ISSUE DATE: **8/90** MODEL: **7CKM--RV,** SUBJECT: **Stator Leads with** NO.: **501**
 REVISION DATE: **--** **10/12CC--Mobile,** **PowerBoost III**
10/12RY--Standby, **or PowerBoost III E**
10/12.5C--Marine **Voltage Regulator**

Figure 1. Stator Leads with Non--PowerBoost III/III E Voltage Regulator

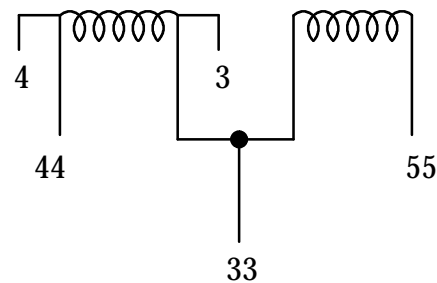
Generator sets produced prior to the use of PowerBoost III and PowerBoost III E voltage regulators had stators with windings 33--44 and 55--66, see Figure 1. Units produced with PowerBoost III and PowerBoost III E voltage regulators have these windings internally connected (center tapped) within the stator. PowerBoost III (X--239753) and PowerBoost III E (X--278598) voltage regulators can be identified by three adjustment pots. Lead 66 is now eliminated as it is combined with lead 33, see Figure 2. Stator connects to (PowerBoost III or PowerBoost III E) voltage regulator using terminals 33, 44, and 55 only. Voltage regulator terminal 66 exists, but is unused as a stator connection.

Terminal 66 on voltage regulator (PowerBoost III and PowerBoost III E) is intended for connection of a remote rheostat in applications where fine voltage adjustment is required. The rheostat will provide a 5 Volt adjustment range. This terminal is NOT intended for connection of stator lead 66 as was done with non--PowerBoost III and III E models.

*Some early 7CKM--RV with PowerBoost III voltage regulators may have a stator with a separate winding 55--66 where lead 66 and 33 are externally connected. In those cases, the following NOTE is required (as stated in the 7CKM--RV Service Manual).

If voltage regulator is removed or replaced, be sure regulator is properly reconnected to generator. Stator lead 66 (along with lead 33) must be connected to voltage regulator terminal 33 or generator damage may result.
